BCA Design Assessment Report

19 Sydney Road, Manly

Project: 17-19 Sydney Road, Manly
 Document Type: BCA Design Assessment Report
 Report Number: P221_387-02(BCA) JR

Figure C1.1 – Exposed Rooflight (Levels 1 & 2)

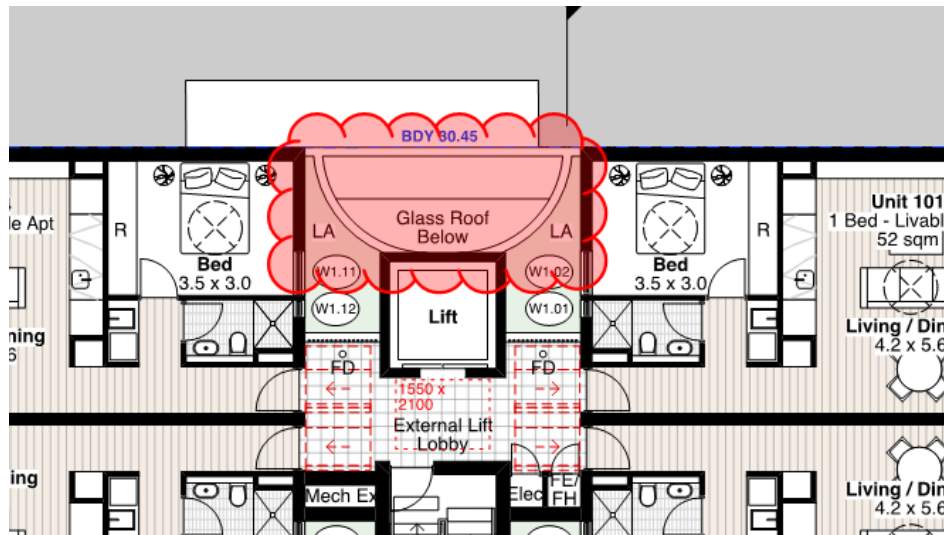
An assessment of the drawings shows that there is a skylight located within 3m of a fire source feature, being the side boundary. Therefore, the following design options are available to achieve compliance with the BCA –

- (i) Option 1 – Reconfigure the existing layout and relocate the roof lights so that they are not located within a 3m proximity to the side boundary; or
- (ii) Option 2 – Justify exposed skylights within 3m of a side boundary under a performance-based design.

Figure C2.6(a) –Elevation Perspective

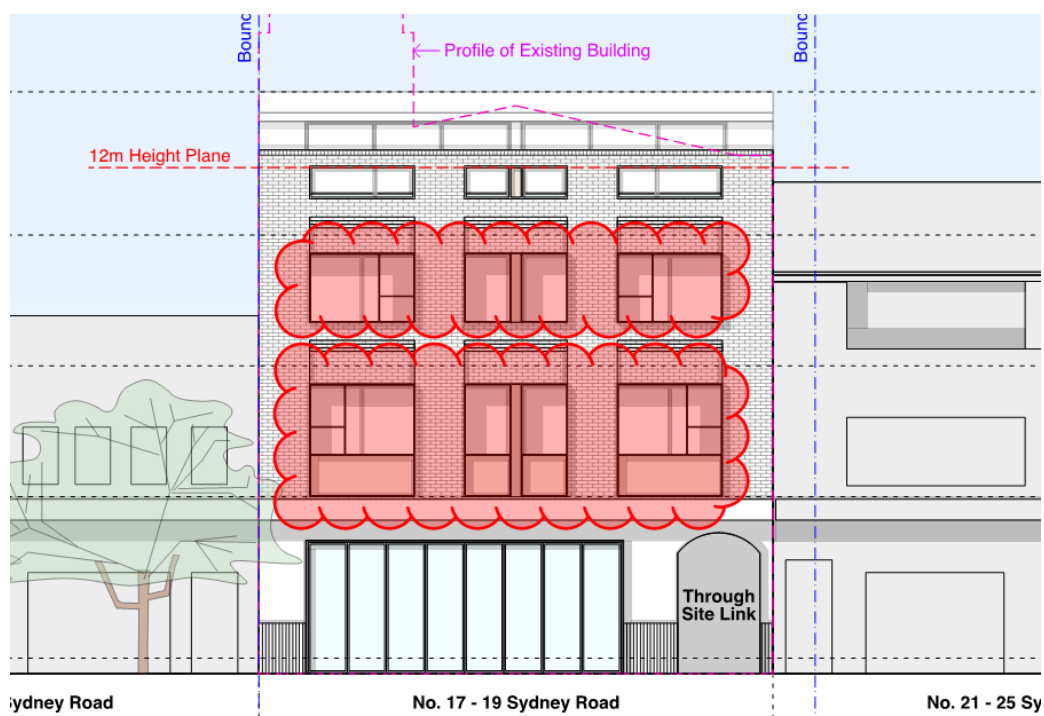
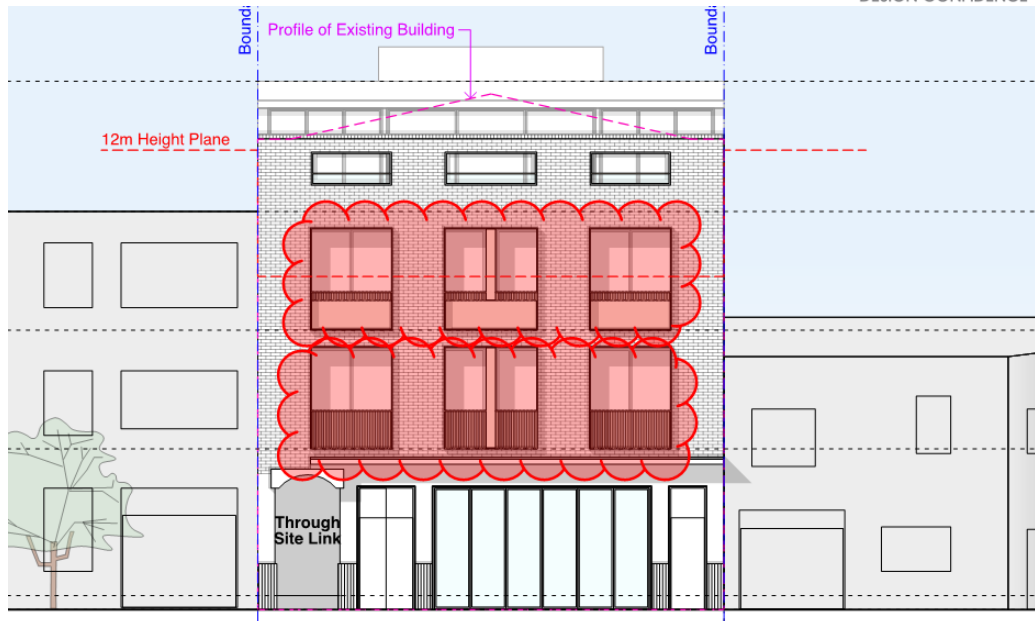
An assessment of the proposed development shows that separation is not achieved to the following areas –

Southern Façade

In addition to the above, further details are required confirming that separation of vertical openings to the eastern and western façade.

Figure D1.2 – Egress within the basement storey

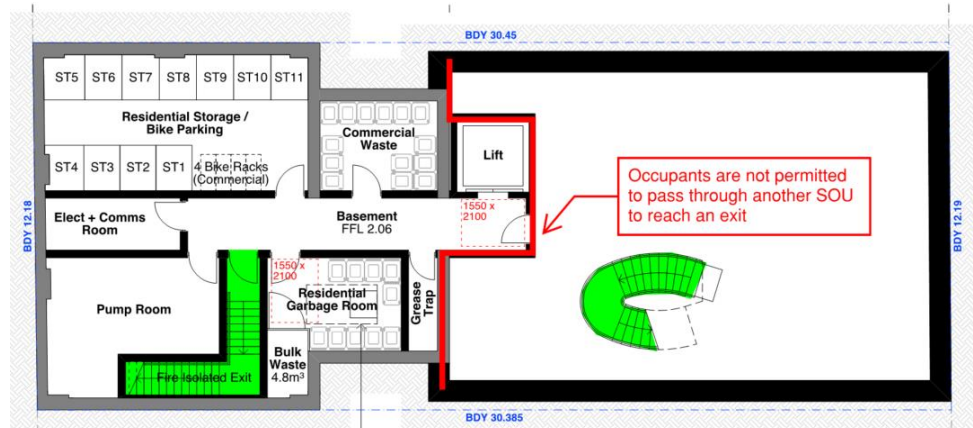
D1.2	An assessment of the floor plans shows that parts of the basement storey will not have access to two exit where egress does not necessitate passing through another sole occupancy unit. It is recommended that the proposed layout is reviewed and justified under a performance-based design from the projects fire engineer.
------	---

Figure E1.3(a) – Pumproom doorway does not open directly into an exit

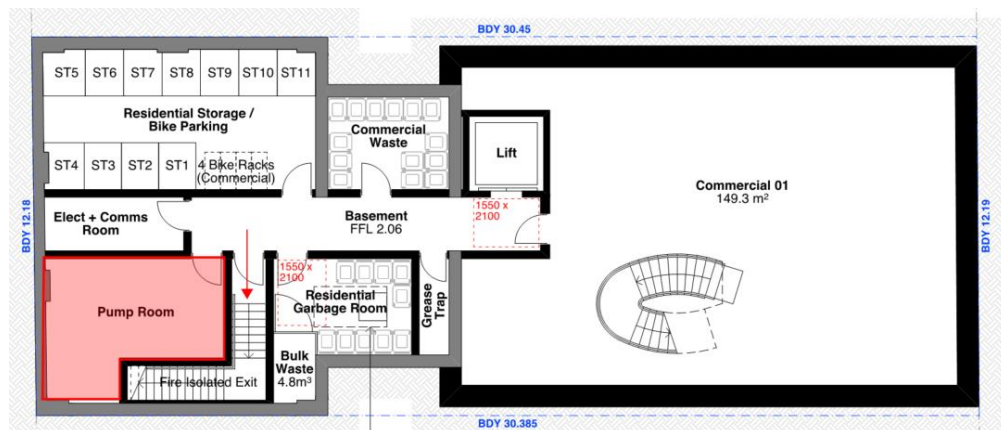
An assessment shows that the booster assembly and pumproom will be located within areas of the building which may impede on brigade invention. It is recommended that the projects fire engineer reviews and justifies the following under a performance based design –

Pumproom

Justify the basement pumproom not opening directly into open space or a fire isolated exit.

Figure E1.3(b) – Hydrant booster is not permitted to be located within the building

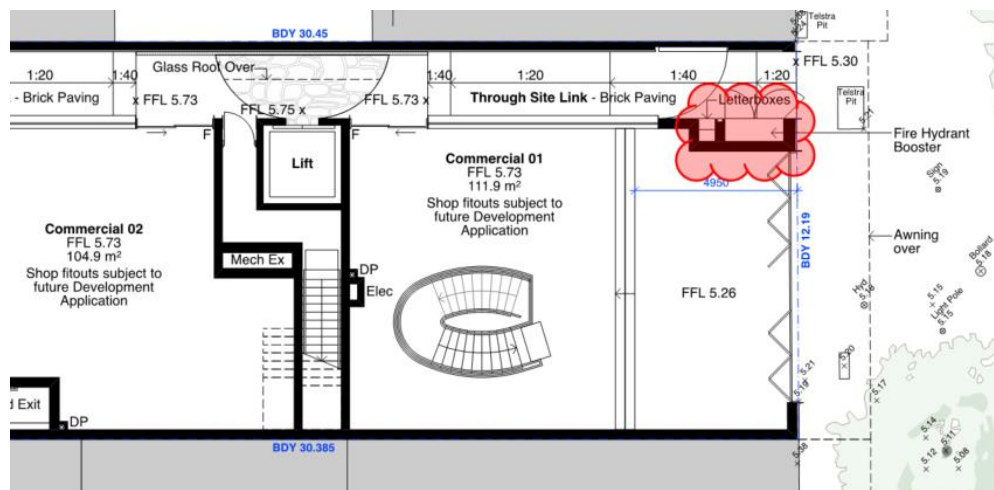
Booster Assembly

- Located within 10m of the building and not protected in accordance with subclause 7.3(c)(ii) of AS2419.1-2005; and
- Provided as an 'I' Pattern
